STAFF RECOMMENDATION 2615 West Linden Avenue June 19, 2019

Application: New Construction—Addition; Partial Demolition
District: Hillsboro-West End Neighborhood Conservation Zoning Overlay
Council District: 18
Base Zoning: RS7.5
Map and Parcel Number: 10415027900
Applicant: Craig Kennedy
Project Lead: Melissa Sajid, melissa.sajid@nashville.gov

Description of Project: Application is to construct a rear addition that extends wider than the historic house, to demolish an existing rear addition, and to alter windows on both side façades of the historic house.

SITE PLAN

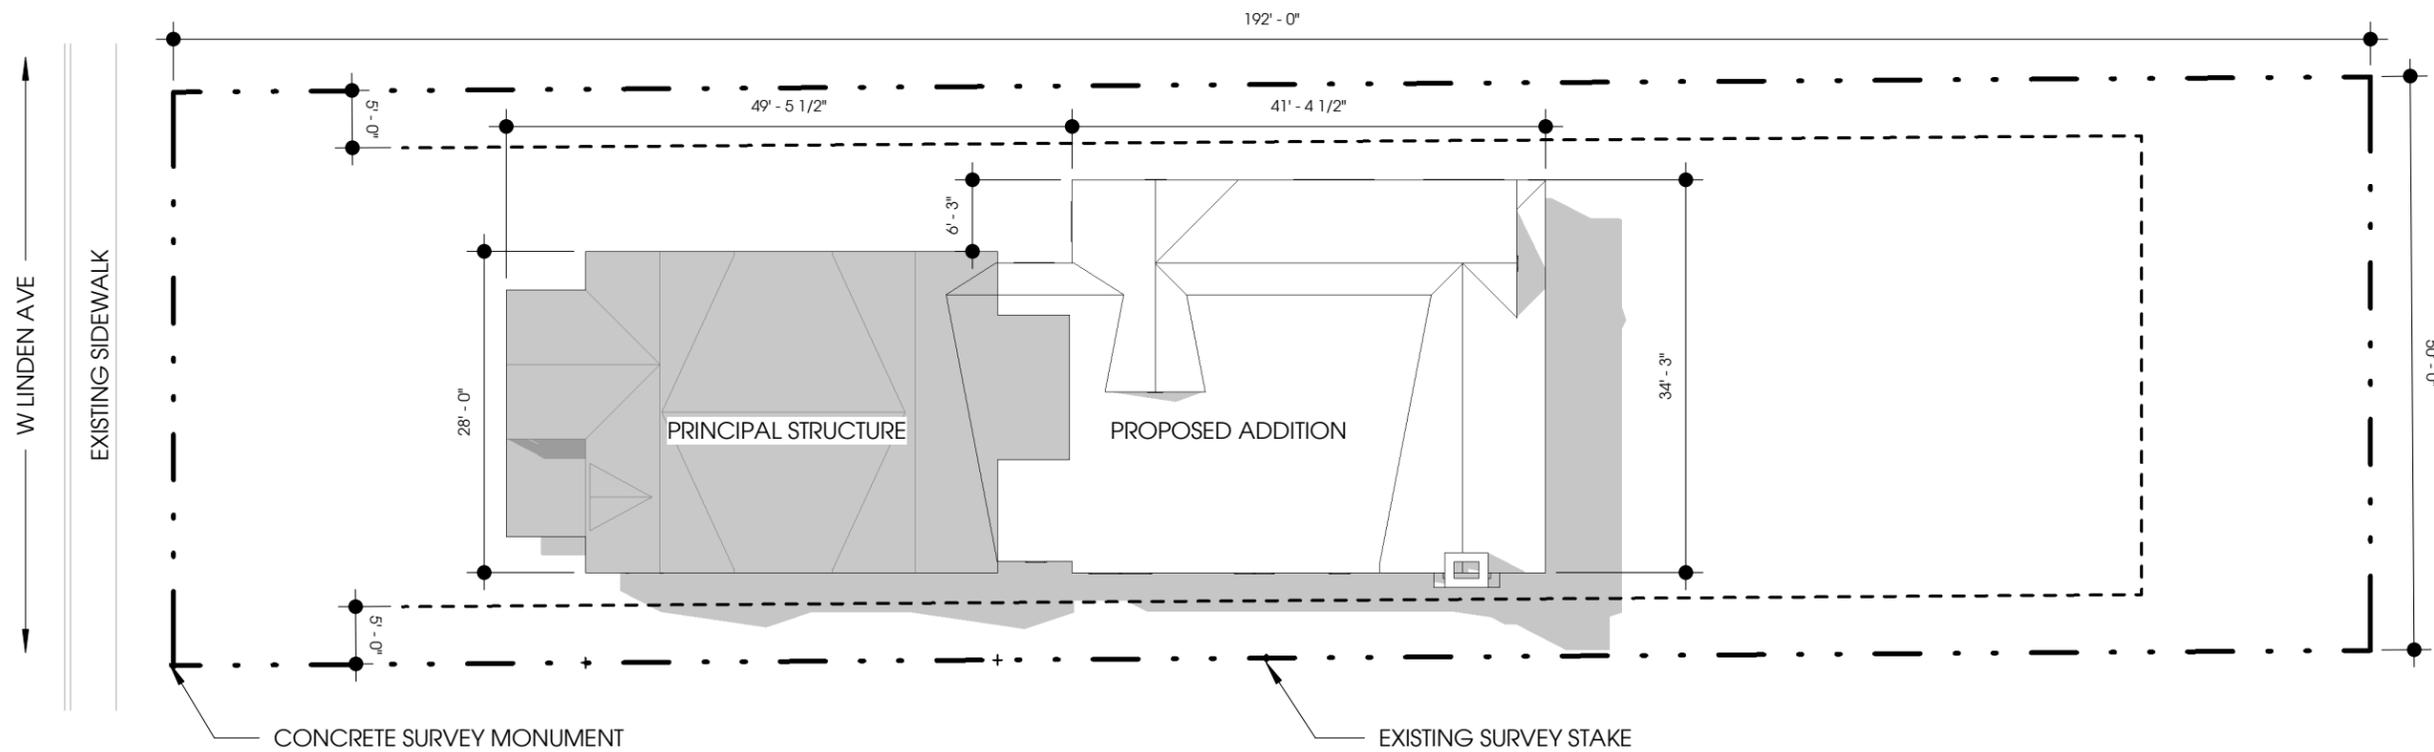
Setback & Rhythm of Spacing: The project meets all base zoning requirements. The addition will have a left side setback of approximately eight feet (8') and a right-side setback of seven feet (7'). The rear of the addition will be approximately seventy-two feet (72') from the rear property line.

FLOOR PLAN

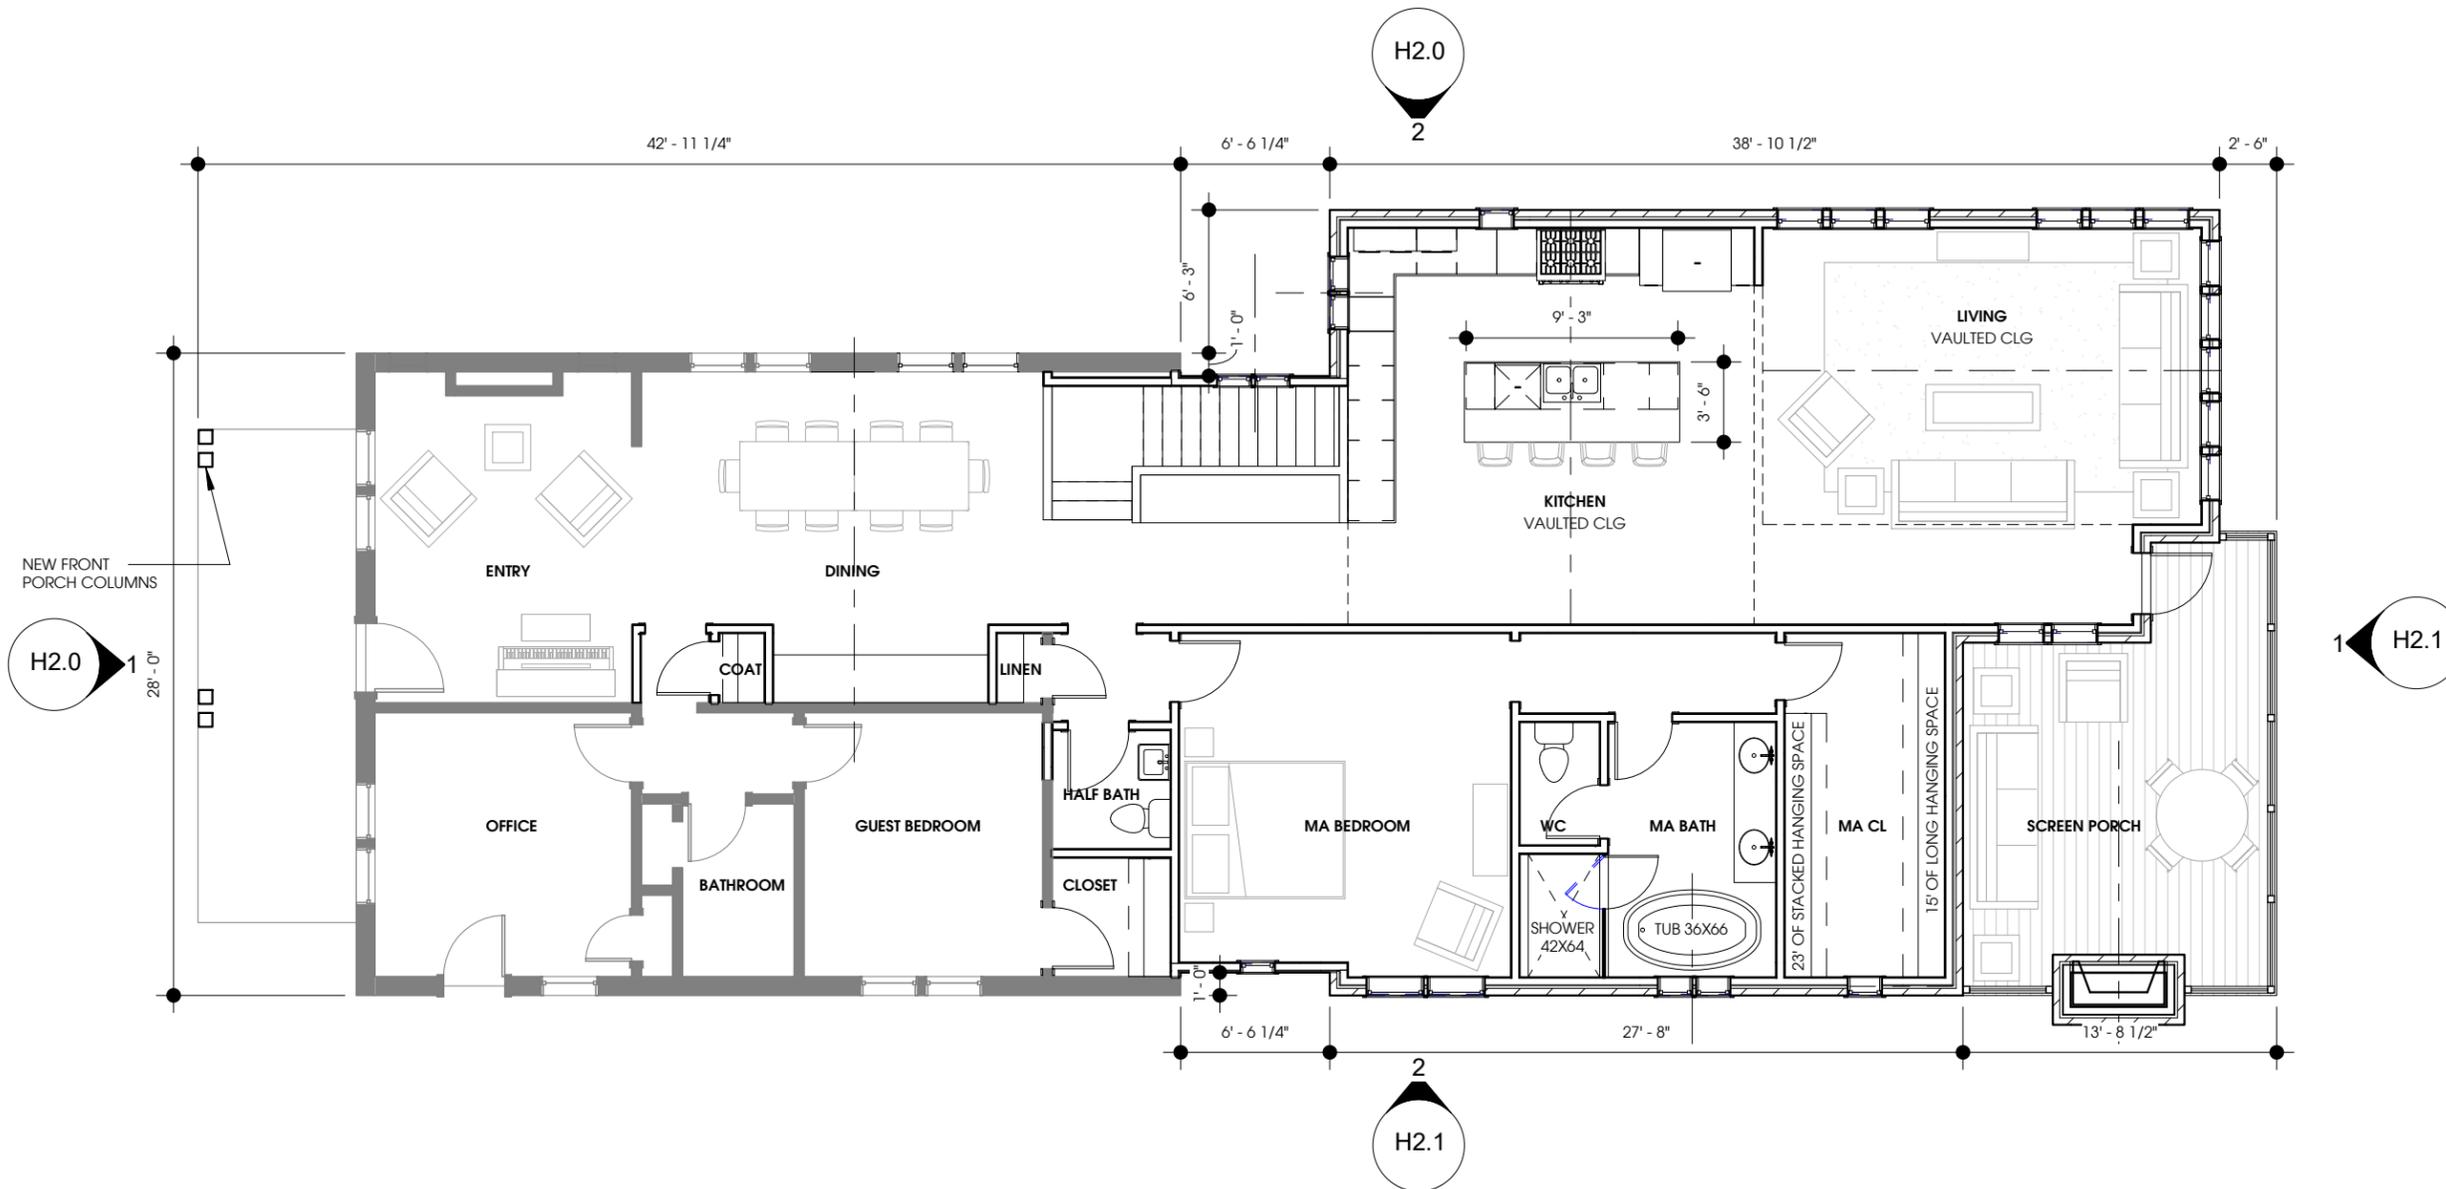
Height & Scale: The new construction has a net footprint of approximately one thousand, four hundred thirty-six square feet (1,436 sq. ft.) compared to the existing footprint, which is one thousand, one hundred, and seventy-one square feet (1,171 sq. ft.). While the addition more than doubles the footprint of the existing house, staff finds that it could be appropriate in this case given the somewhat small footprint of the historic house and the appropriate scale of the addition. The ridge, eave, and foundation heights will match those of the historic house.

The proposed addition ties in three feet (3') below the ridge of the historic house and then goes back fifteen feet (15') before rising to match the height of the existing house. The addition will be no taller than the historic house.

The addition extends six feet, three inches (6'-3") wider on the left side. Per the design guidelines, wider additions can be appropriate in cases where the house is narrow (30' wide or less) and shifted on the lot. This historic house meets those conditions as it is twenty-eight feet (28') wide and shifted to the right side of the lot.

Design, Location & Removability: The addition will be located at the rear of the existing building and will be inset one foot (1') from both rear corners as required by the design

guidelines for single-story additions. On the right side, the addition widens at six feet, six inches (6'-6") back to match the width of the historic house. On the left side, the addition widens at six feet, six inches (6'-6") back and extends six feet, three inches (6'-3") wider than the side wall of the historic house. The house meets the criteria for when a wider rear addition can be appropriate. The addition also meets the design criteria for wider additions as it is single-story with a side gabled roof form, and the width is no more than half the width of the historic house. For these reasons, staff finds that the proposed wider rear addition may be appropriate.

1. Staff approve the final details, dimensions and materials of the foundation material, windows, doors, and rear porch posts prior to purchase and installation;
2. Staff shall approve a brick sample prior to purchase and installation; and,
3. The HVAC shall be located behind the house or on either side, beyond the midpoint of the house, and utility meters shall be located on the sides or rear of the building. Alternative mechanical and utility locations must be approved prior to an administrative sign-off on building permit(s).

WEST ELEVATION

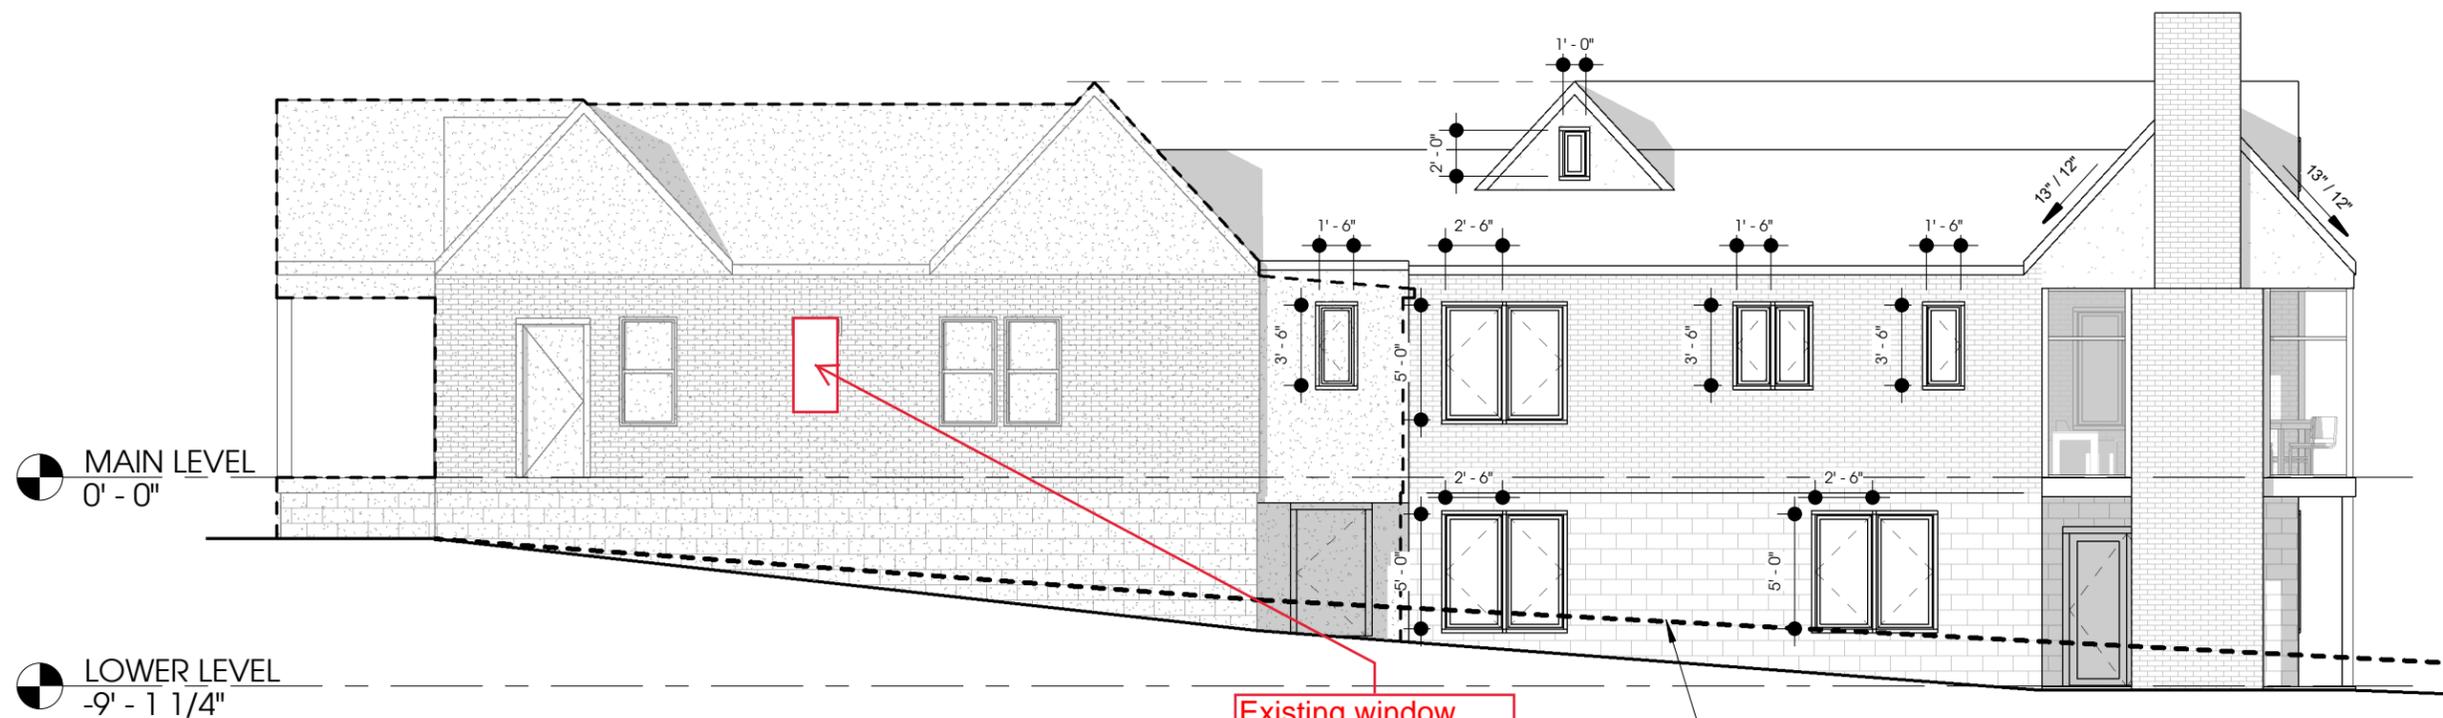
Existing window was altered on the interior without a preservation permit. The opening size and location was not altered on the exterior. Staff found the partial demolition to be appropriate since the opening size and location have not been altered on the exterior..
